Addendum No. 3 page I

Project: 2018 Renovations & Improvements

Jeffersonville Township Public Library

Project No.: 1723.02

AD-3a

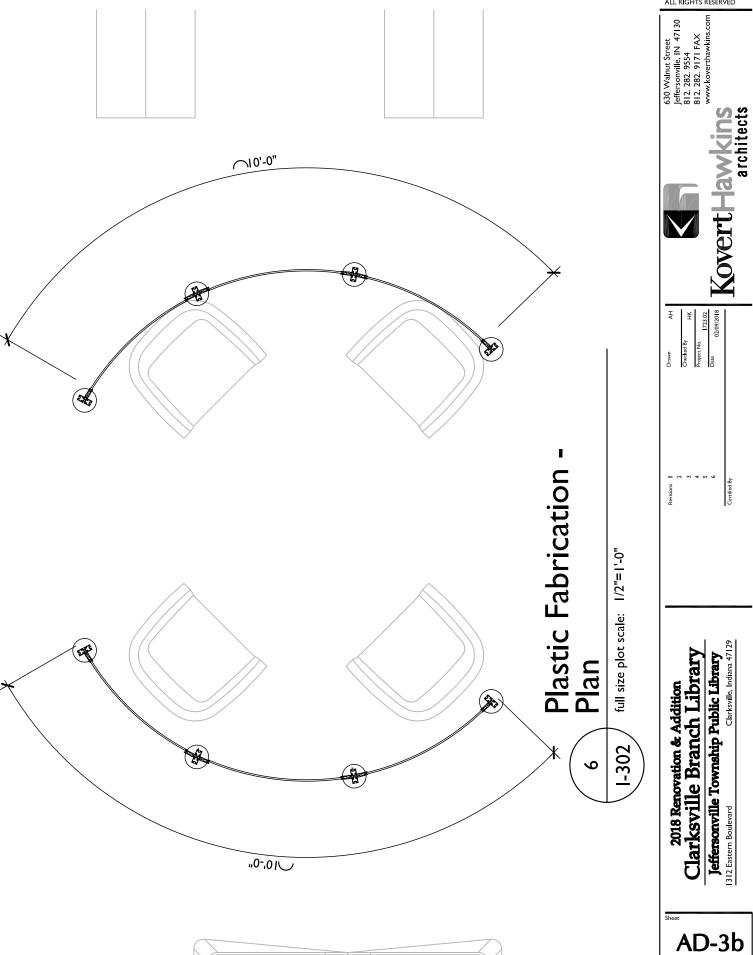
8. E-201 - Electrical Power Plan Add Detail 2 per attached Drawing AD-3a.

ALL CONDUITS TO BE CUT FLUSH WITH TOP OF SLAB. NOTE

COORDINATE EXACT ROUGH-IN DIMENSIONS AND IDENTIFY SLAVE PEDESTAL FOR 120V CIRCUIT TERMINATION WITH OWNER'S SEPARATE VENDOR.

AD-3c

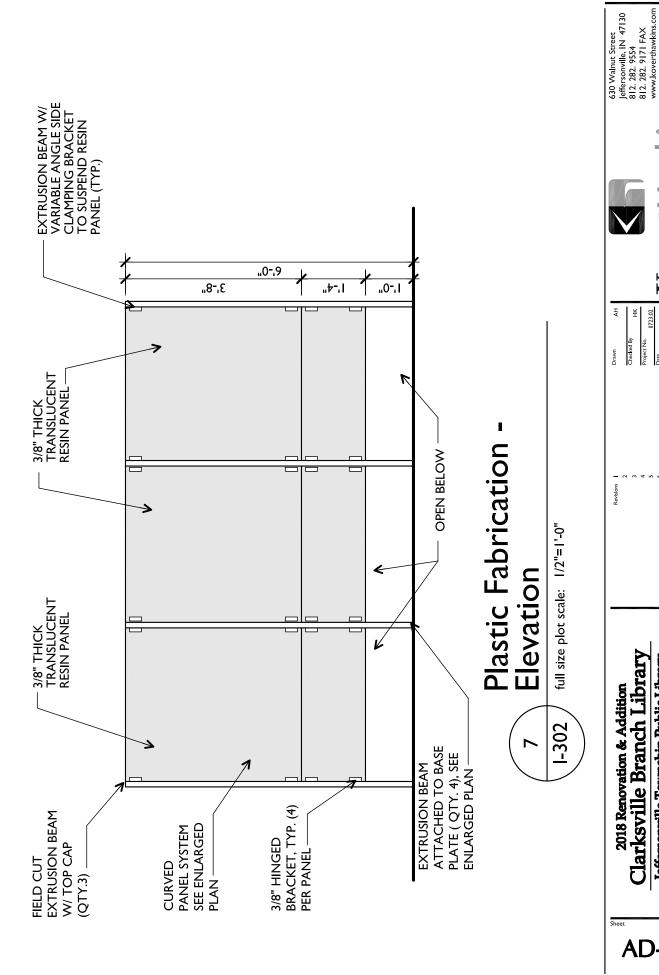
Revise Plan 6/I-302 per attached Drawing AD-3b. Revised Elevation 7/I-302 per attached Drawing AD-3c.
